REPLACING PAGE ADDENDUM
Filing Instructions:

**SWITCHING SYSTEM NO. 301A
LINE-UP AND OVERALL TESTS**

1.001 This addendum supplements Section 480-708-501, Issue 1. The attached pages must be inserted in the section in accordance with the filing instructions above.

Fig. 3—Overall Transmission Sketch of 301A SS

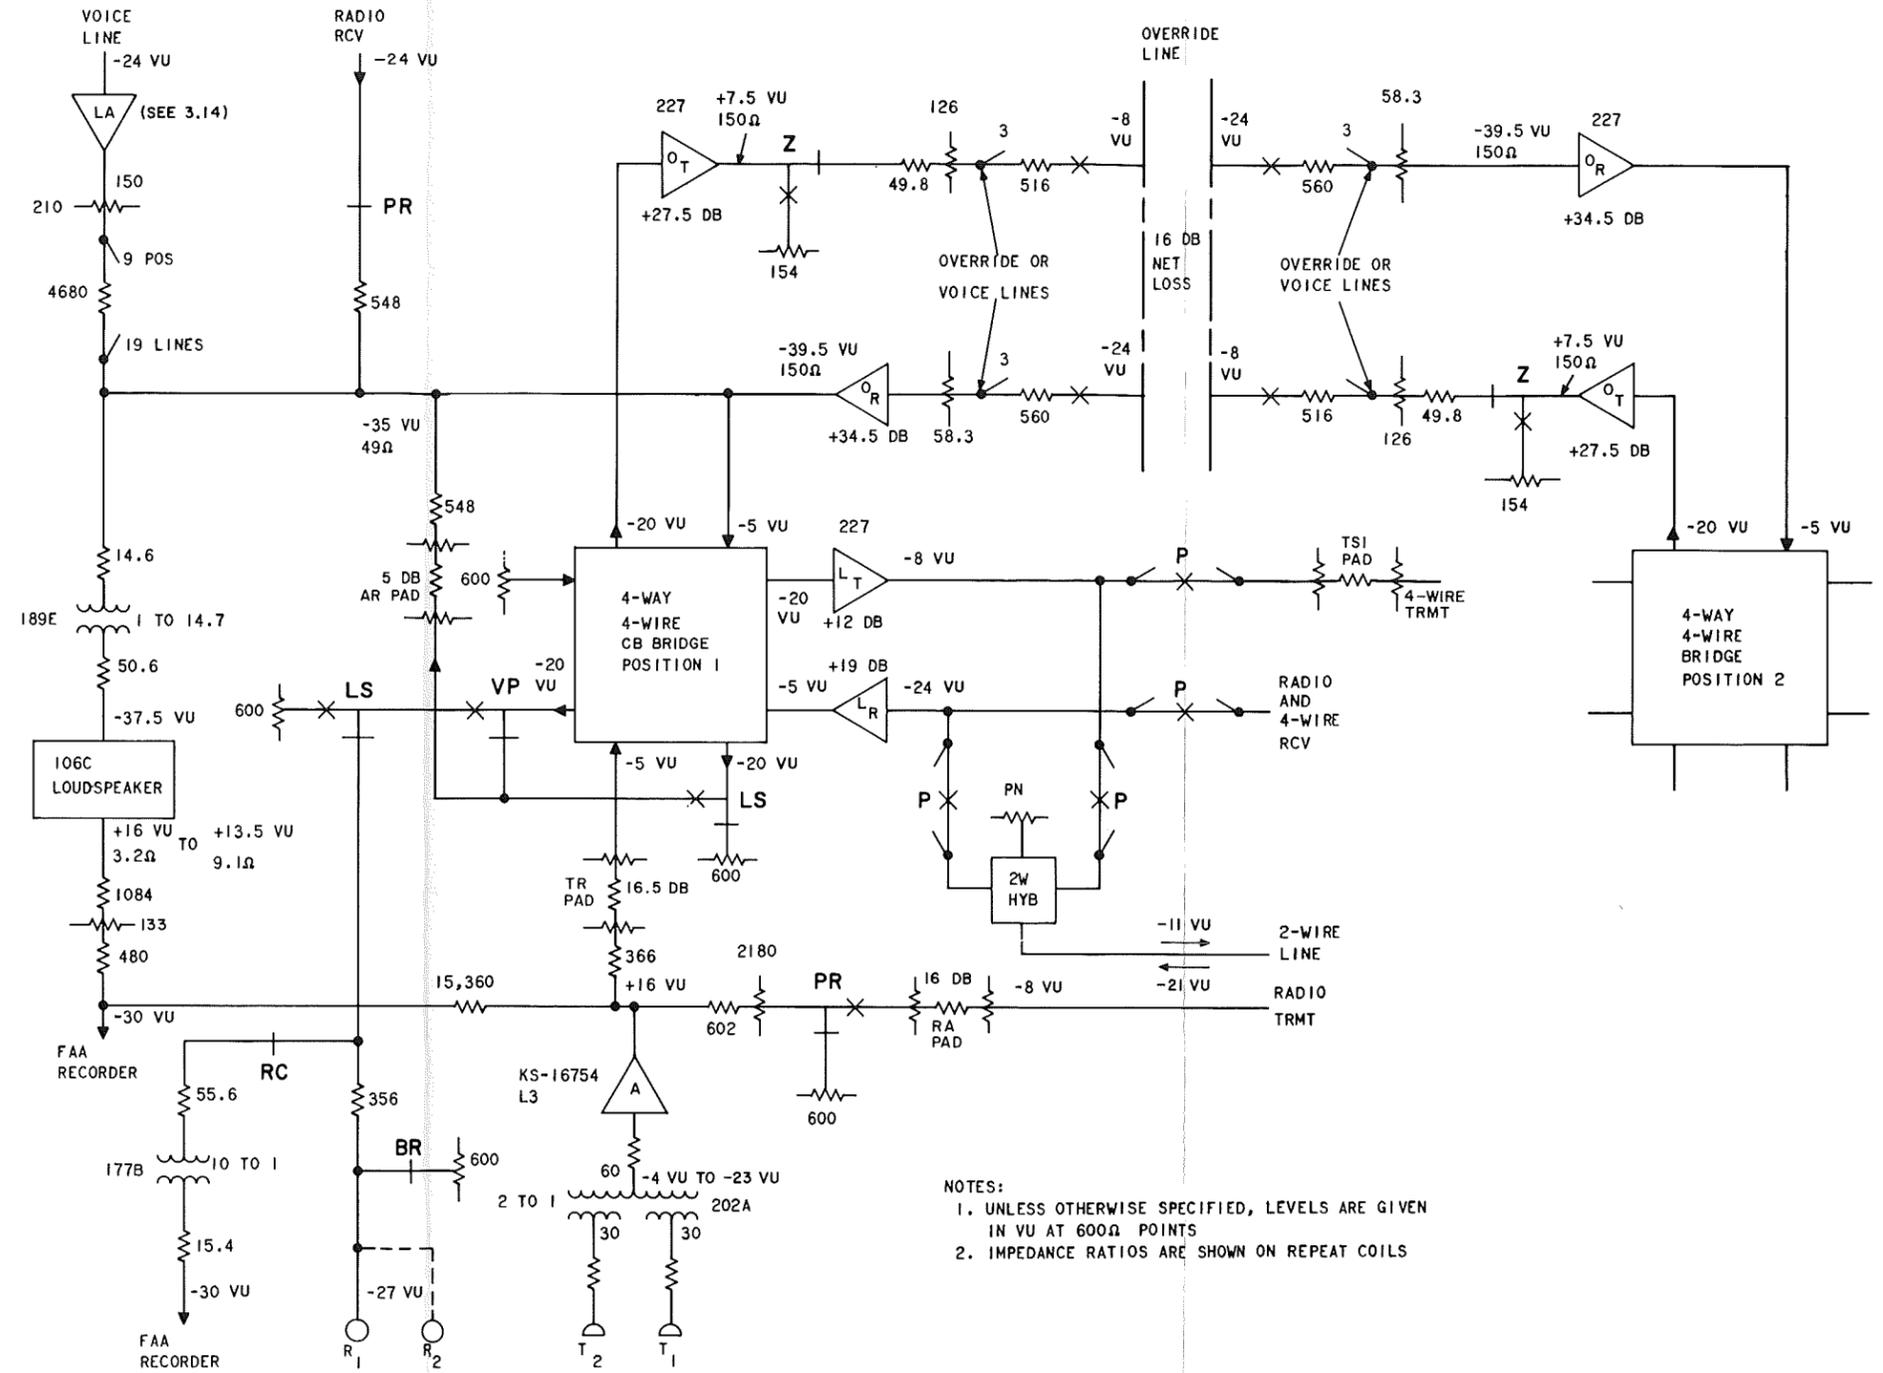
1.002 This addendum is issued to change the voice transmission level units from dB to

Vu in Fig. 3, and to change the wording for the ZN option in 6.01.

- (a) Part 3, Fig. 3—revised
- (b) Part 6, 6.01—revised .
